UNITED STATES OF AMERICA
NUCLEAR REGULATORY COMMISSION

In the Matter of
Southern Nuclear Operating Company
License Amendment Application for
Combined Licenses NPF-91 and NPF-92
Vogtle Electric Generating Plant Units 3 and 4
Docket Nos. 052-00025 and 052-00026;
NRC-2008-0252-0057

DECLARATION OF ARNOLD GUNDERSEN TO SUPPORT THE
PETITION FOR LEAVE TO INTERVENE AND REQUEST FOR HEARING
BY THE BLUE RIDGE ENVIRONMENTAL DEFENSE LEAGUE REGARDING
SOUTHERN NUCLEAR OPERATING COMPANY'S
VOGTLE ELECTRIC GENERATING PLANT UNITS 3 AND 4
REQUEST FOR LICENSE AMENDMENT AND EXEMPTION:
CONTAINMENT HYDROGEN IGNITER CHANGES (LAR-15-003)

Thermal Image of Radiation Leaking From Fukushima Daiichi Unit 3 Containment

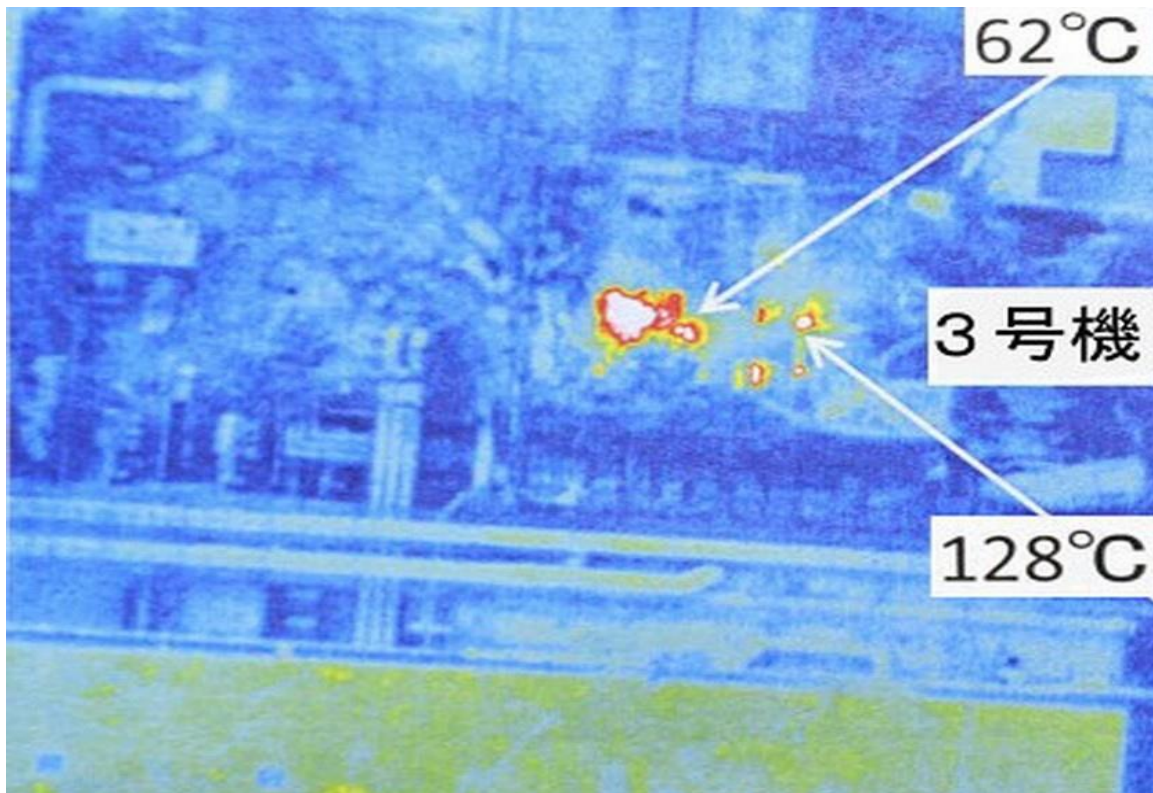
- 34.3. Below is a infrared photograph of Fukushima Daiichi Unit 3 taken by TEPCO several weeks after Unit 3 was destroyed by a detonation shockwave.
- 34.4. The reader is directed to the 128C gases being vented at the center of the photo. This cannot be steam, as it exceeds 100C and must therefore be hot radioactive gases being released directly from the top of the containment.

34.5. The AP1000 containment could react in a similar fashion if the proposed hydrogen igniters are installed.
